Access Compliance Report Public Rights-of-Way (Curb Ramps)

Main Street: N/A Cross Street: SKLAR_ST Location: SE

ADA ID: RPRK211202113004 Ramp Type: Type 4 - Parallel Initial Pass/Fail: Pass Overall Compliance: No Severity Score: 20

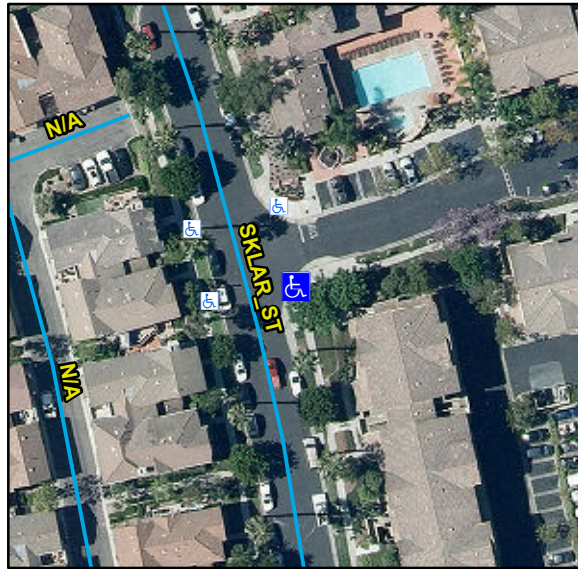
Compliance	Description	Data	Compliance	Description	Data
N/A	Ramp Length LT (in)	130	N/A	Ramp Length RT (in)	122
Yes	Ramp Width LT (in)	88	Yes	Ramp Width RT (in)	88
Yes	Ramp Run Slope LT (%)	0.9	Yes	Ramp Run Slope RT (%)	8.3
Yes	Ramp Cross Slope LT (%)	1.8	Yes	Ramp Cross Slope RT (%)	1.2
N/A	Landing Present	No	No	DWS Provided	No
N/A	Landing Length (in)	N/A	N/A	DWS Contrast	N/A
No	Landing Width (in)	N/A	N/A	DWS Length (in)	N/A
No	Landing Run Slope (%)	N/A	N/A	DWS Full Width	N/A
No	Landing Cross Slope (%)	N/A		DWS Offset Type	N/A
N/A	Landing Movement Obstructed?	No	N/A	DWS Offset Left (in)	N/A
	Landing Movement Type	Curb	N/A	DWS Offset Right (in)	N/A
N/A	Landing Shared	N/A			
N/A	Clear Space	Yes			
N/A	Clear Space To Crosswalk (in)	48			
N/A	Marked Crosswalk 1	No	N/A	Marked Crosswalk 2	No
	Crossing 1 Direction	N		Crossing 2 Direction	W
	Marked Crosswalk 1 Width (in)	N/A		Marked Crosswalk 2 Width (in)	N/A
N/A	Ramp Inside Crosswalk 1	N/A	N/A	Ramp Inside Crosswalk 2	N/A

Crossing 1 Slope (%)	0.5		Crossing 2 Slope (%)	2.3
	Crossing 1 Cross Slope (%)	0.9		Crossing 2 Cross Slope (%)	1
Yes	Gutter Ponding	No	No	Curb Slope	10.5
Yes	Gutter Lip Height (in)	0		Road Run Slope (%)	1.7
Yes	Gutter Run Slope (%)	2.6		Road Cross Slope (%)	0
No	Gutter Cross Slope (%)	2.1	No	Perpendicular Joint Present	No
Yes	Overall Surface Condition	Acceptable			
	Cross Gutter Present?	No		Spandrel Present?	No
	Replace Cross Gutter?	N/A		Replace Spandrel?	N/A

Remove & Replace Curb Ramp With Two New Directional Ramps or Equivalent. Remove & Replace Gutter.
